**Economic Commission for Europe****Inland Transport Committee****World Forum for Harmonization of Vehicle Regulations****Working Party on Lighting and Light-Signalling****Seventy-fifth session**

**Simplification of lighting and light-signalling Regulations****Proposal for Supplement 45 to the 03 series of amendments  
to Regulation No. 37 (Filament lamps)****Submitted by the Informal Working Group "Simplification of the  
Lighting and Light-Signalling Regulations"\***

### Luminous centre and shapes of filaments lamps

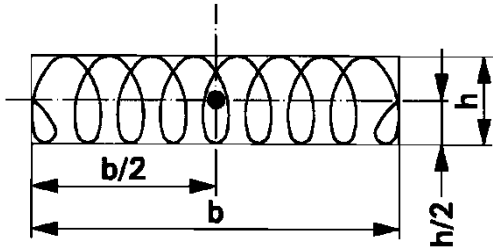
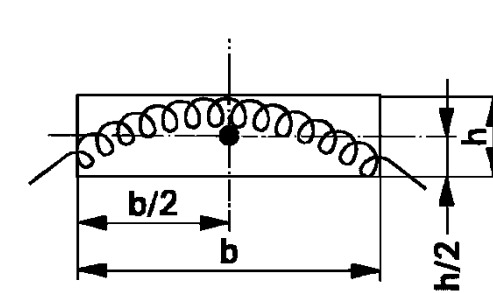
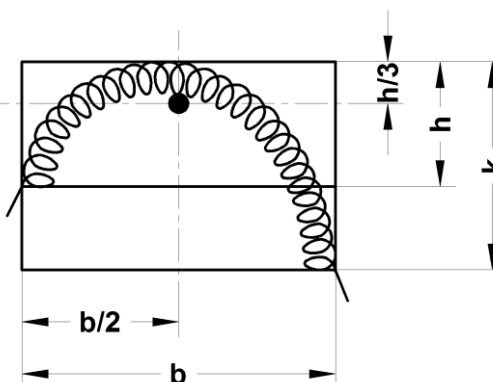
Save as possible ~~standard~~ **annex** Unless otherwise stated on the filament lamp light source data sheets, this **annex** is applicable to the determination of the luminous centre of different filament shapes.
